STAFF REPORT
COMMUNITY DEVELOPMENT DEPARTMENT

HEARING DATE: July 1, 2021
TO: Planning & Zoning Commission
FROM: Sonya Allen, Associate Planner
208-884-5533
SUBJECT: H-2021-0035 – TM Creek Apartments
Phase 3
LOCATION: South of W. Franklin Rd. and east of S.
Ten Mile Rd., in the NW ¼ of Section
14, Township 3N., Range 1W. (Parcel
#R8483040240)

TEN MILE CREEK APARTMENTS III
 MERIDIAN, IDAHO
 CONDITIONAL USE PERMIT QUALIFIED OPEN SPACE EXHIBIT

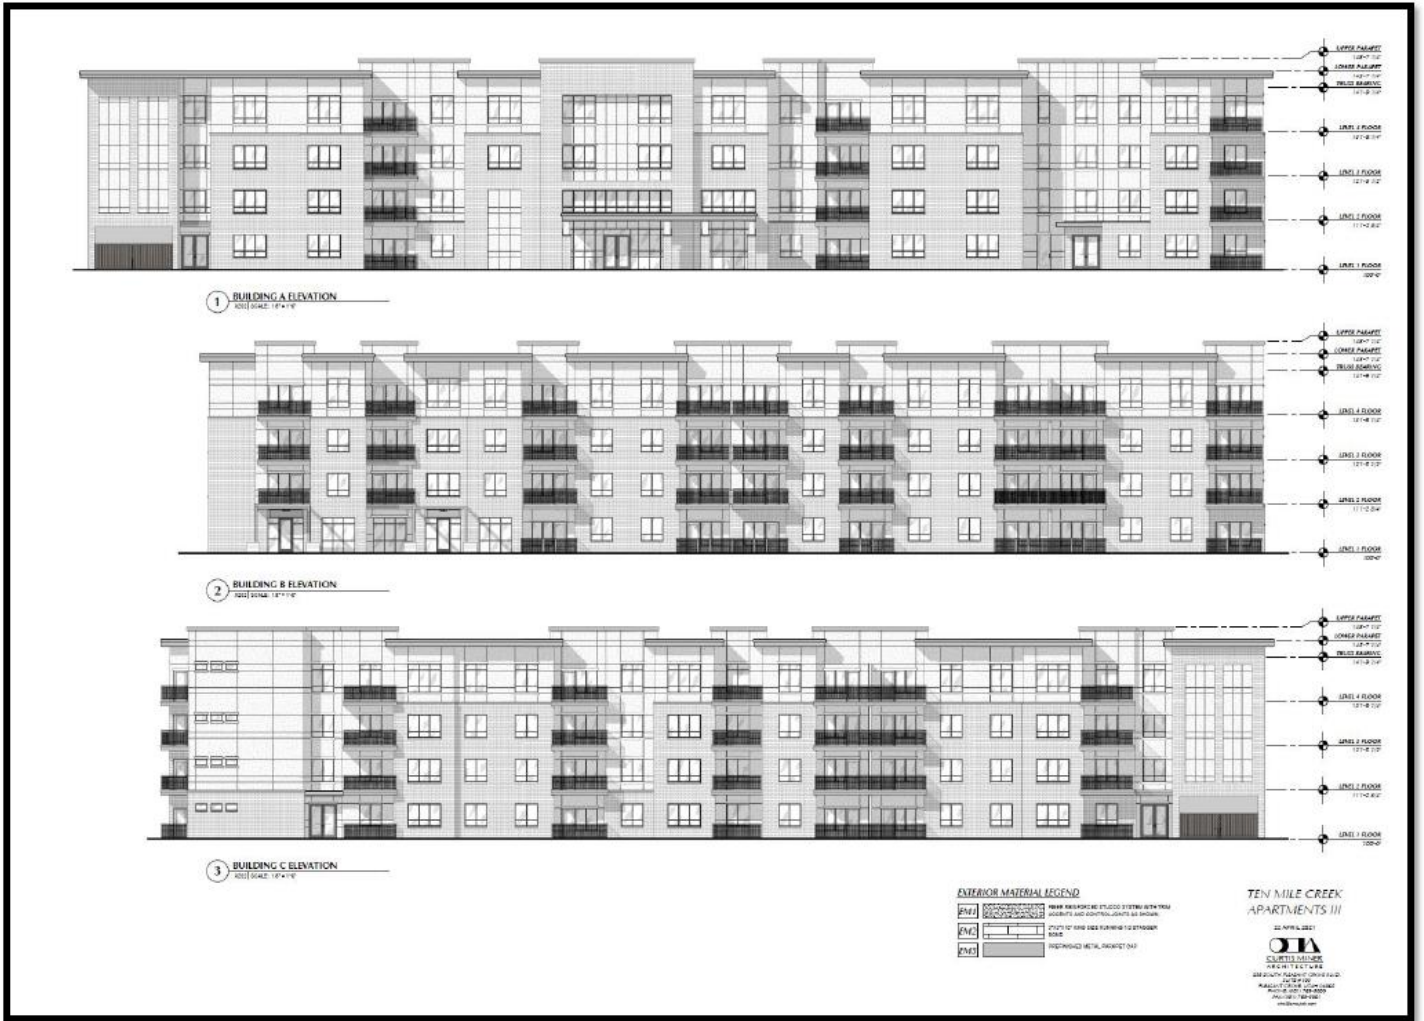
2. Common open space shall be not less than four hundred (400) square feet in area, and shall have a minimum length and width dimension of twenty feet (20'). *The common open space areas depicted on the open space exhibit in Section VIII.D meet this requirement.*
